Access Compliance Report

Public Rights-of-Way

(Curb Ramps)

Intersection ID: 42362	Main Street: OSPREY_KNOLL_DR	Cross Street: HERON_GLEN_DR	Location: E
ADA ID: F07B6B44DE54	Ramp Type: BlendTrans1	Initial Pass/Fail: Fail	Overall Compliance: No
Severity Score: 8.75			
Codes/Mitigation Info/Possible Solution		Field Measurements/Component Compliance

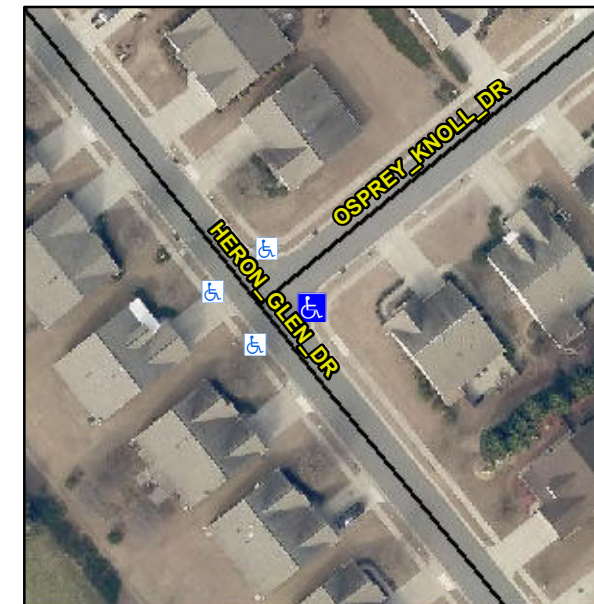
Not Found, R304.5.1

Compliance	Description	Data	Compliance	Description	Data
N/A	Ramp Length (in)	46.0	Yes	BlendTrans Slope (%)	2.6
No	Ramp Width (in)	38.0	Yes	BlendTrans XSlope (%)	2.0
N/A	Flare Type LT	N/A	N/A	Flare Type RT	N/A
N/A	Flare Slope LT (%)	N/A	N/A	Flare Slope RT (%)	N/A
N/A	Flare Traversable LT?	N/A	N/A	Flare Traversable RT?	N/A
N/A	Landing Length (in)	N/A	N/A	DWS Provided?	N/A
N/A	Landing Width (in)	N/A	N/A	DWS Contrast?	N/A
N/A	Landing Slope (%)	N/A	N/A	DWS Length (in)	N/A
N/A	Landing X Slope (%)	N/A	N/A	DWS Full Width?	N/A
N/A	Landing Curb? (Y/N)	N/A	N/A	DWS Offset (in)	N/A
N/A	Shared Landing?	N/A			
N/A	Gutter Ponding?	N/A	N/A	Gutter Slope (%)	N/A
N/A	Gutter Lip Ht (in)	N/A	N/A	Gutter X Slope (%)	N/A
N/A	Painted X Walk1?	No	N/A	Painted X Walk2?	No
	X Walk 1 Direction	To NW		X Walk 2 Direction	To SW
	X Walk 1 Width (in)	N/A		X Walk 2 Width (in)	N/A
	X Walk 1 Slope (%)	3.6		X Walk 2 Slope (%)	0.7
	X Walk 1 X Slope (%)	1.9		X Walk 2 X Slope (%)	2.2

N/A	Ramp inside XWalk1?	N/A	N/A	Ramp inside XWalk2?	N/A
	Road Slope (%)	1.8		Clear Space?	N/A
	Road X Slope (%)	2.1	N/A	Clear Space to XWalk (in)	N/A
N/A	Any Obstructions?	N/A	N/A	Storm Grate/Utility Hazard?	N/A
	Obstruction Type			Storm Grate/Utility Type	
		N/A			N/A
			Yes	Surface Condition? (G/P)	Good
			No	Curb Slope (%)	15.4

Remove & Replace Curb Ramp With Two New Directional Ramps or Equivalent.
